ENGINEERING BULLETIN

Subject: Instinct/Prestige Vent Terminations

Date: 7/27/2021

Fig. 8

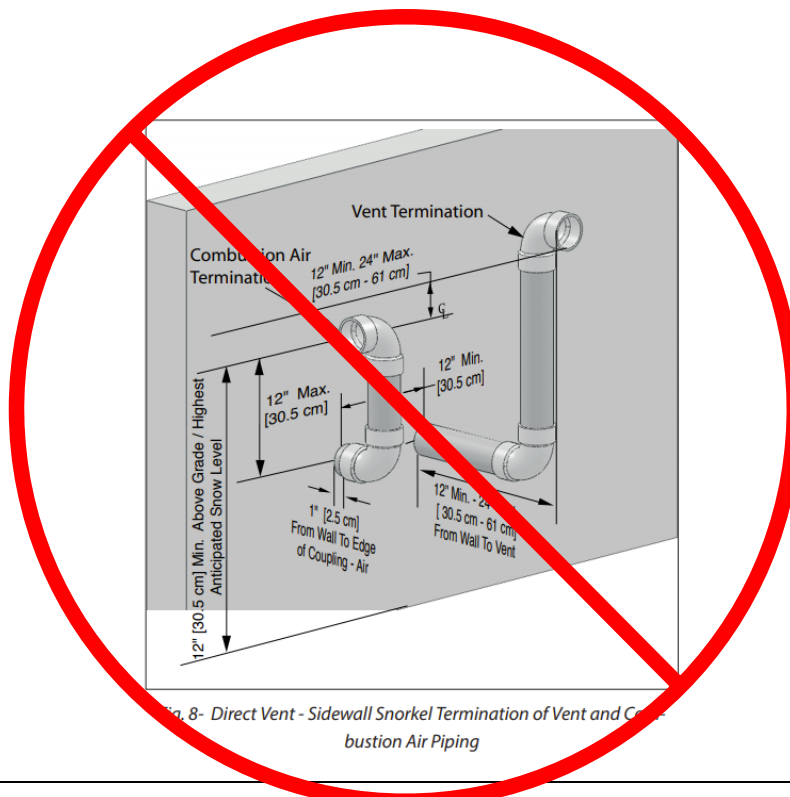
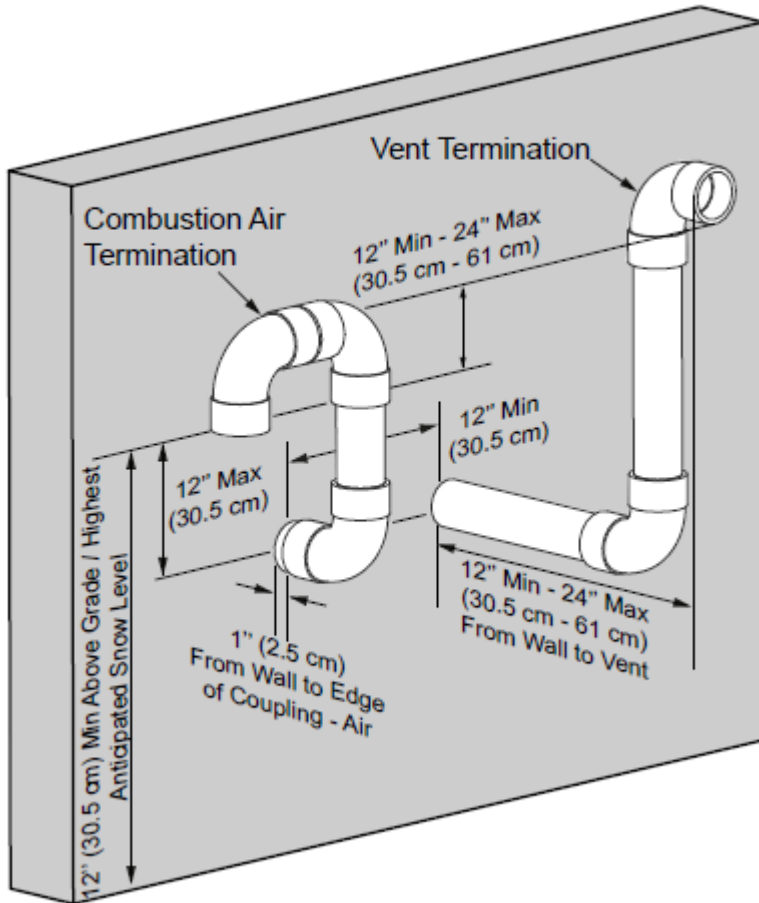
The Instinct Vent Guide and Prestige Vent Guide shows multiple installations where the combustion air termination comes out of the sidewall and terminates in the horizontal position (shown in Figs. 8, 12, 13). This should be shown with the combustion air termination with an additional 90° elbow pointing down toward the ground.

The Combustion Air Termination in the horizontal orientation may lead to rainwater getting into the piping under specific weather conditions.

Instinct and Prestige venting termination configurations in figs 8, 12, and 13 are no longer allowed. All affected installations should be adjusted so that the combustion air piping terminates with 180° bend with the intake opening facing the ground using two 90° elbows. The termination must be located 12" [30.5 cm] (18" [45.7 cm] in Canada) above the highest anticipated snow level.
